ALTICO SERVICE BULLETIN

#ASB 060700

SUBJECT: STIFFENER IN TOP FLAP OF DOLPHIN MAIN CONTAINER

**INSPECTION AND REPAIR/UPDATE OF DOLPHIN MAIN TOP
FLAP IN COMPLIANCE WITH SERVICE BULLETIN #ASB 060700**

FIG. 1

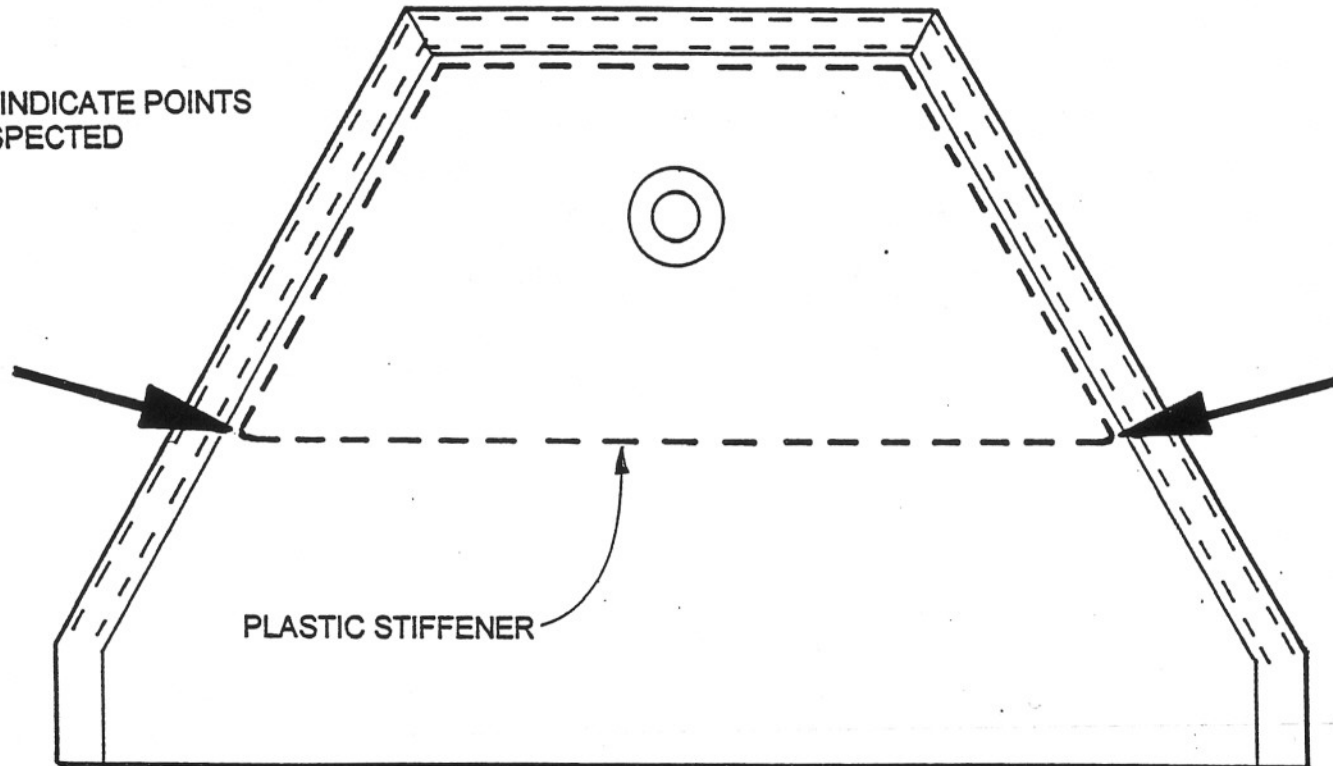
On the underside of the top flap of the main container, the corners of an unreinforced stiffener may wear through the fabric covering. Although this condition may easily escape notice during normal repacking, the exposed corner can catch a suspension line, producing a horseshoe malfunction. One such incident was reported in December of 1999, with the reserve fortunately deploying through the malfunctioned main which remained caught by a suspension line after a cutaway had been attempted. In May 2000 a report was received that a rigger had noticed this condition during a routine inspection/repack, and the exposed corner was covered prior to the next jump.

Before Next Jump: Inspect any DOLPHIN system manufactured prior to February 2000. Determine if reinforcing tape is present. If not present, determine if the stiffener has worn through at points indicated in FIG. 1 of the following diagrams. If a corner of the stiffener is exposed, it is MANDATORY that this condition be corrected before the next jump. This repair/update may be performed by a suitably qualified rigger according to the instructions which follow, or by Altico.

ARROWS INDICATE POINTS
TO BE INSPECTED

- 1) Inspect underside of main top flap at points indicated in FIG. 1.
If a corner of the plastic stiffener is exposed by wear, proceed with Step 2.
- 2) With a hot knife, cut a piece of 1" Type IV tape as shown in FIG. 2.
- 3) Remove the stitches from a 1-3/4" (approx.) section of binding tape along each side of the main top flap. The section of removed stitches must be centered on the edge of the stiffener as shown in FIG. 3. This is done so that the ends of the reinforcing tape may be installed under the binding tape.
- 4) Center the prepared piece of 1" Type 4 tape over the edge of the stiffener and stitch as shown in FIG. 4.
- 5) Replace the stitching in the binding, covering the ends of the Type IV reinforcing tape and oversewing approx. 1" on each side.

FIG. 2

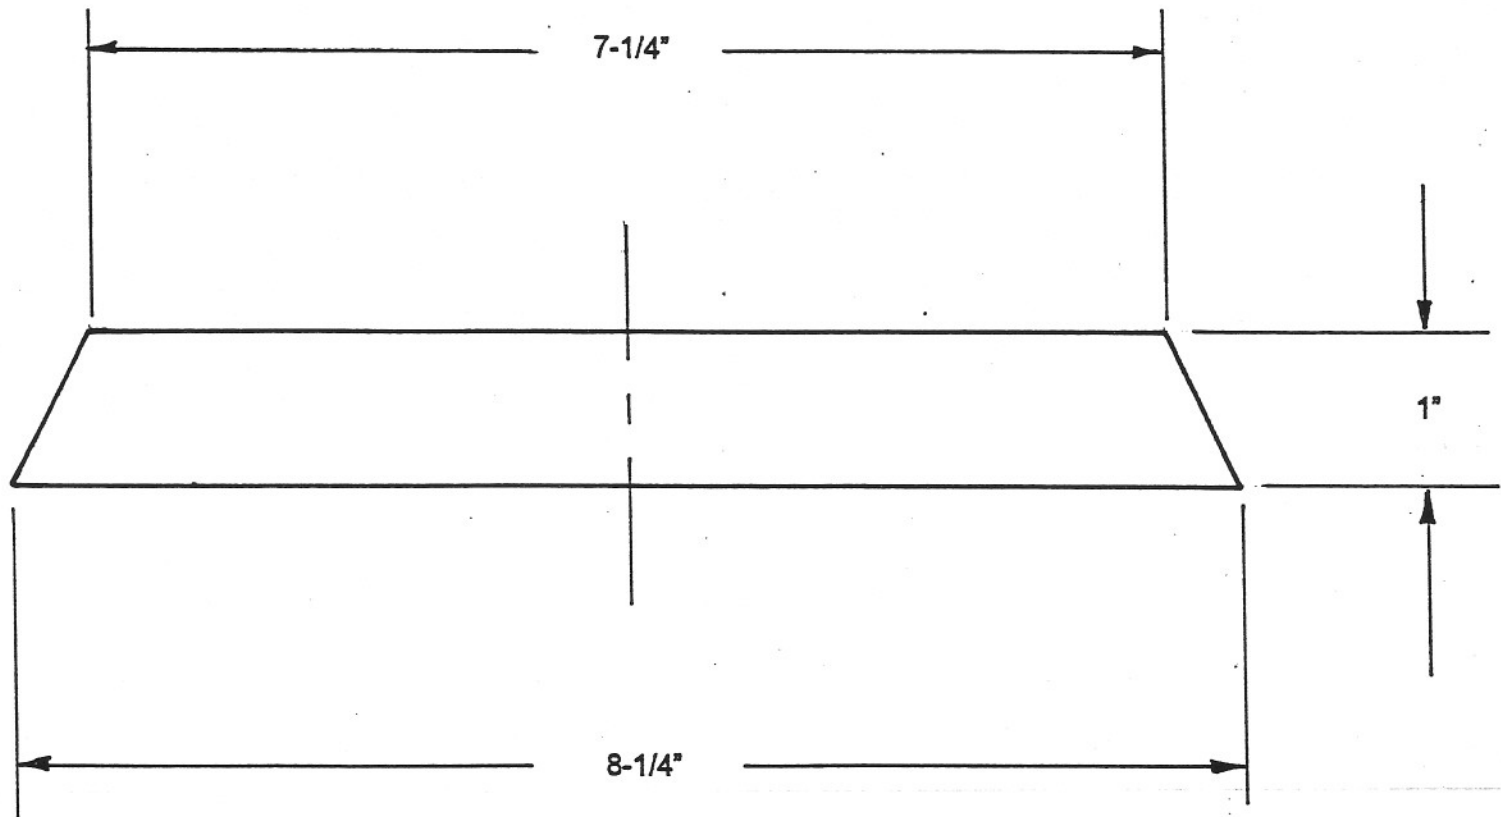
TYPE IV REINFORCING TAPE
